OIL INDIA LIMITED
(A Government of India Enterprise)
P.O. Duliajan – 786602, Assam, India
Website: www.oil-india.com

Corrigendum No. 1 to IFB No. CPG2023P20

**Engineering, Fabrication and Construction, Testing and Commissioning
of Modular Field Gas Gathering Station at Baghjan, Assam**

SINGLE LINE DIAGRAM (PHASE-I)

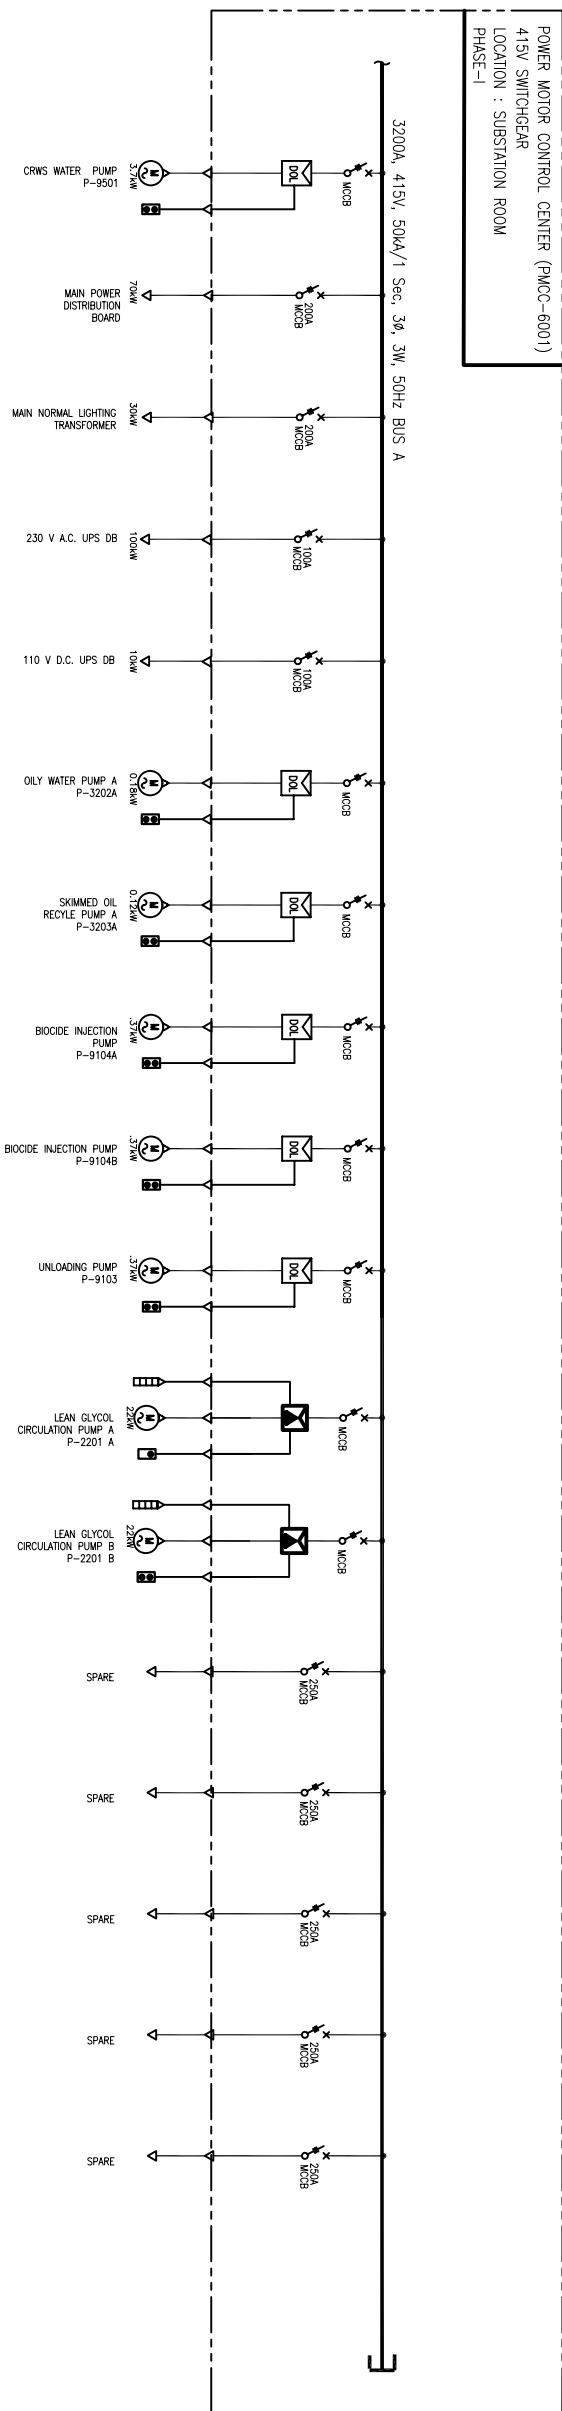
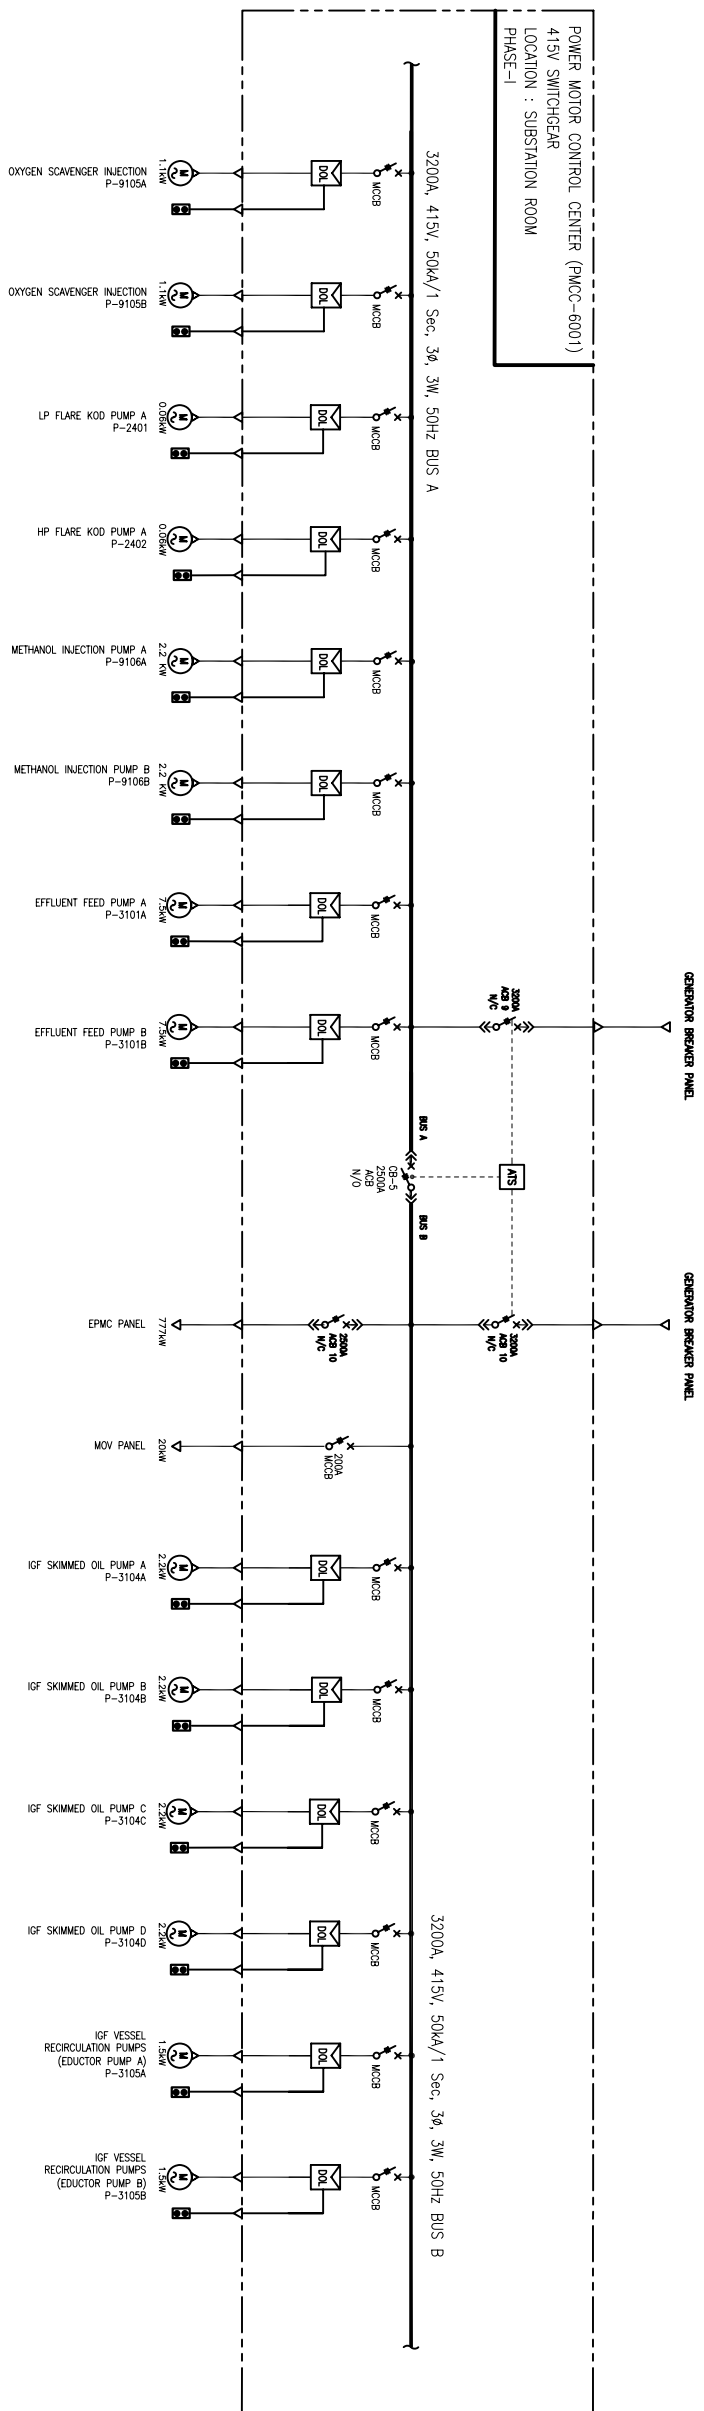
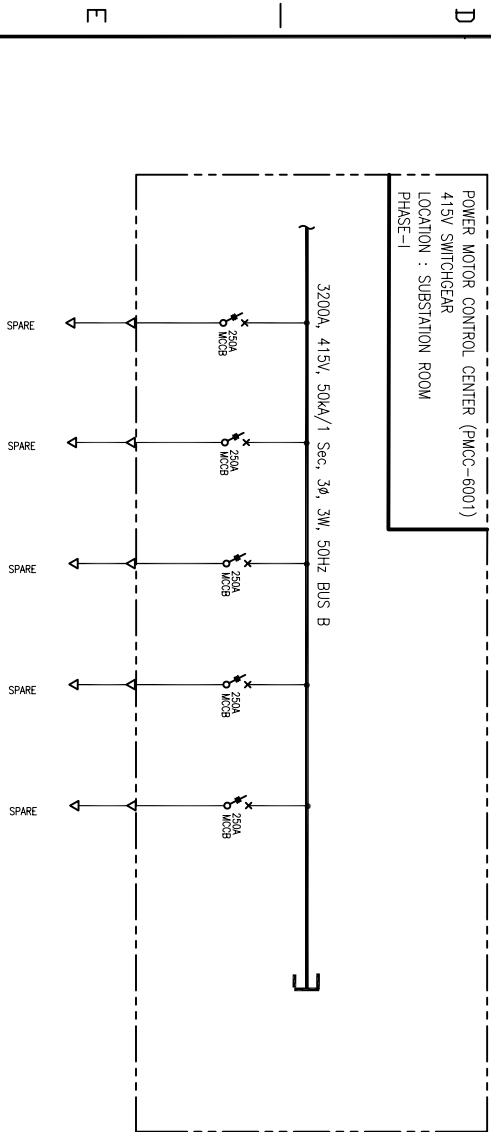
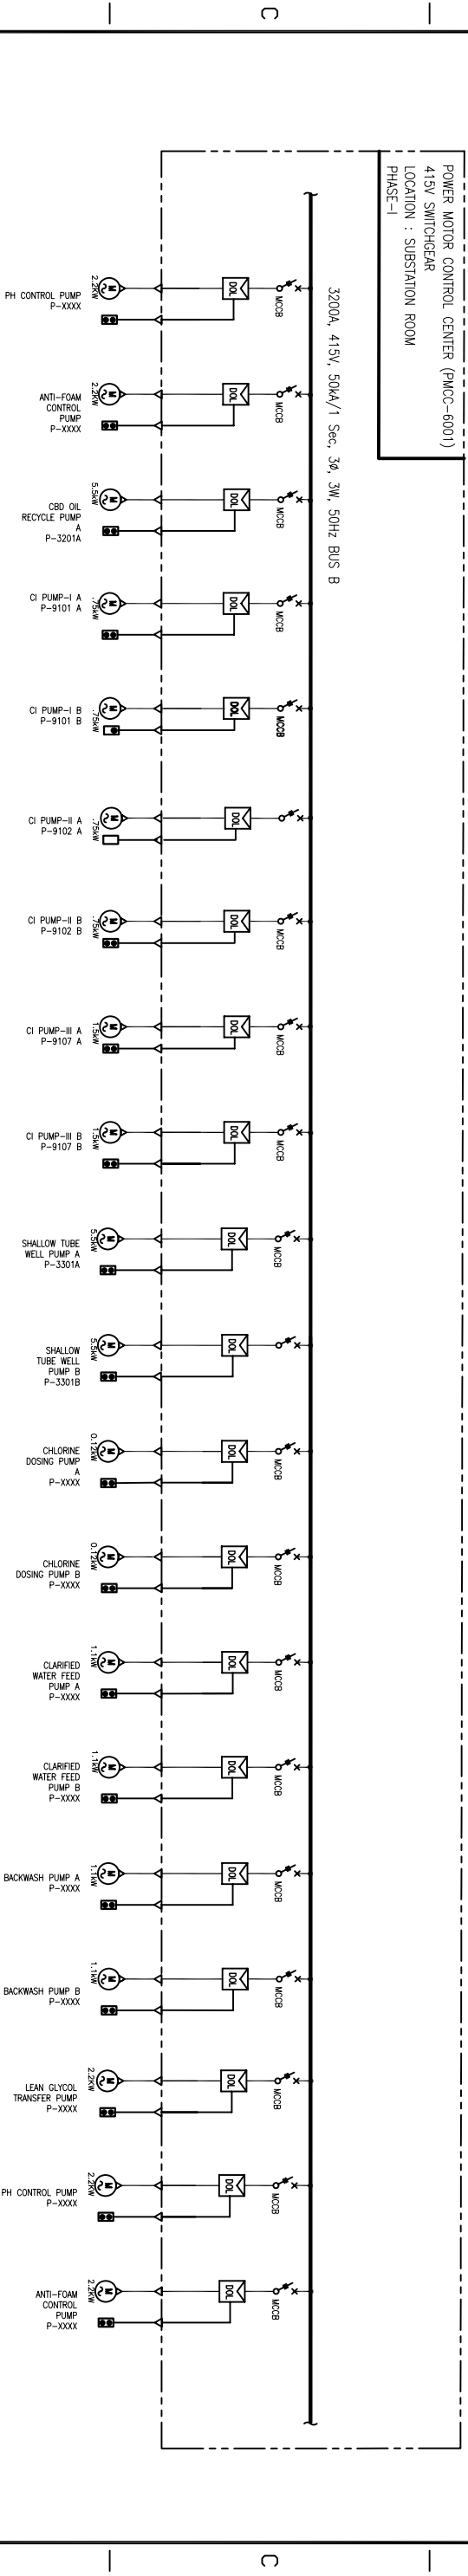
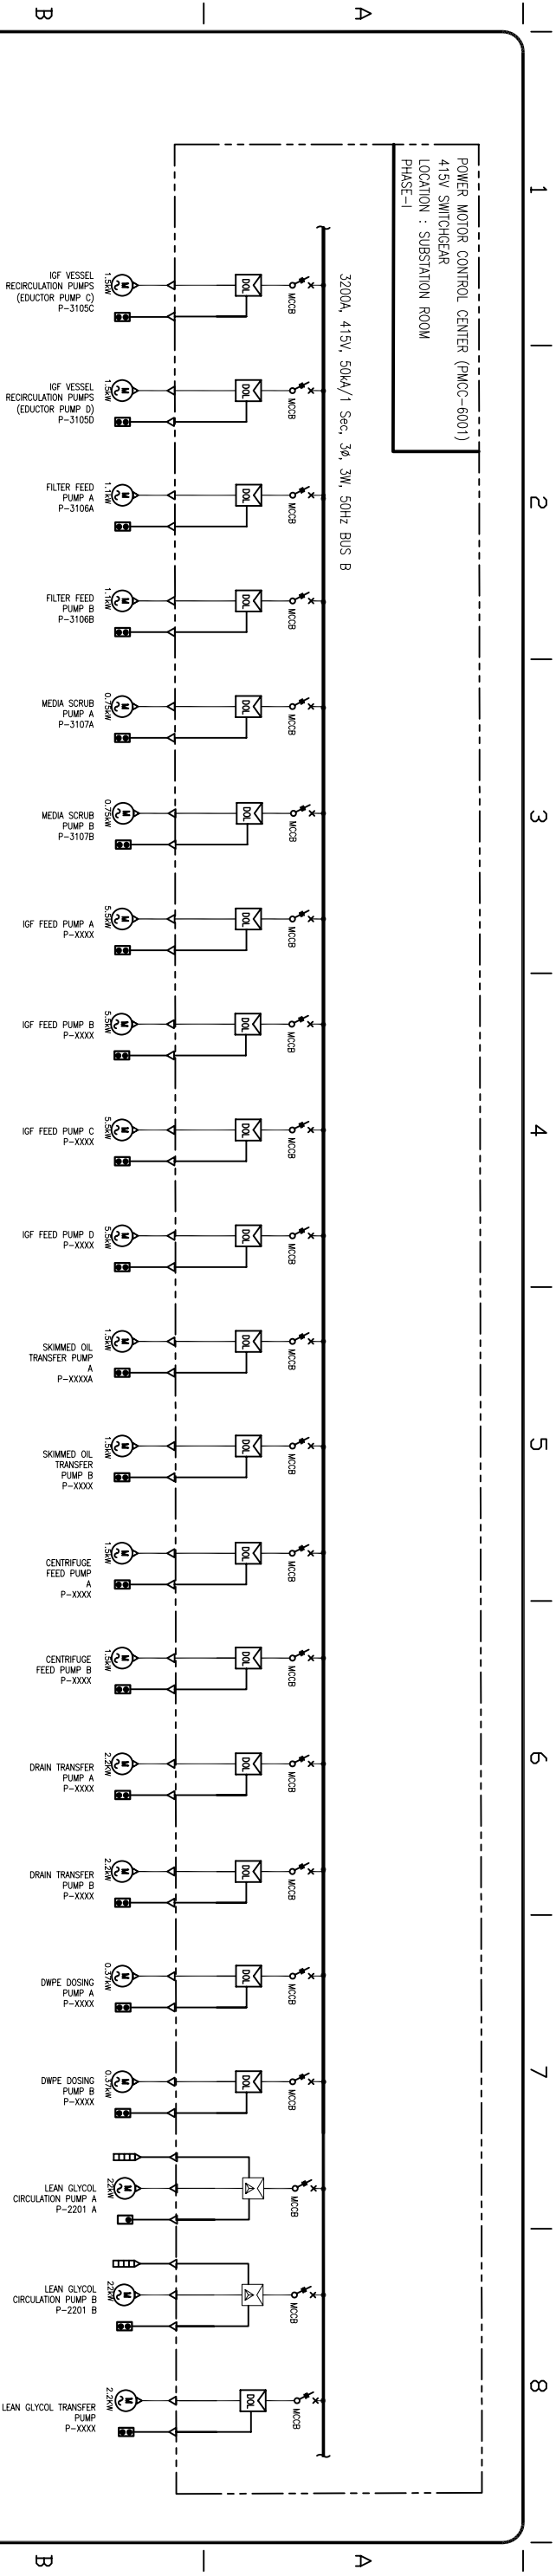
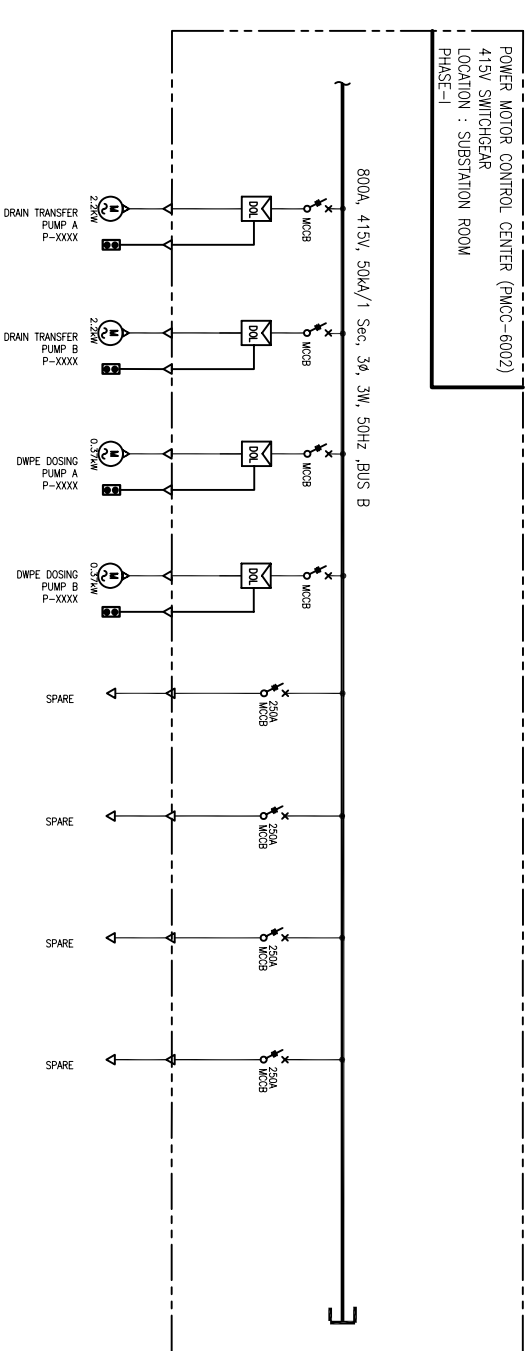
87	Vol.II, Technical Page-1550/ 2248, 1554/2248	Electrical		Equipment Rating Font Not Visible Generator ratings and other details are not visible in the received PDF document. Request to kindly provide drawings with legible text.	Legible Single Line Diagram will be provided along with addendum. Soft copy of the same will be issued along with corrigendum/addendum.

8	Vol-II Technical, Page No. 58 of 2248 Page No. 35 of 278	FGGS-BJN- PRO-PFD-3001		Bidder Understand that the supply of ground water is from existing bore well. Please confirm.	Boring of deep and shallow tube wells shall be under EPC scope. Bore well shall be made in the plant area.
9	Vol-II Technical, Page No. 1250 of 2248	FGGS-BJN-PIP- LAY-5000	Overall Plot Plan	The Overall plot plan given in the tender is in Non-readable format. Kindly provide legible Plot plan.	Legible document will be provided along with <u>addendum / corrigendum</u> .
10	Vol-II Technical, Page No. 1550 to 1555 of 2248	FGGS-BJN- ELC-DIA-6000	SLD	Single Line Diagram, Generator interlock and control is in non-readable format. Kindly provide legible Single Line Diagram.	Legible Single Line Diagram shall be provided as Attachment – 2
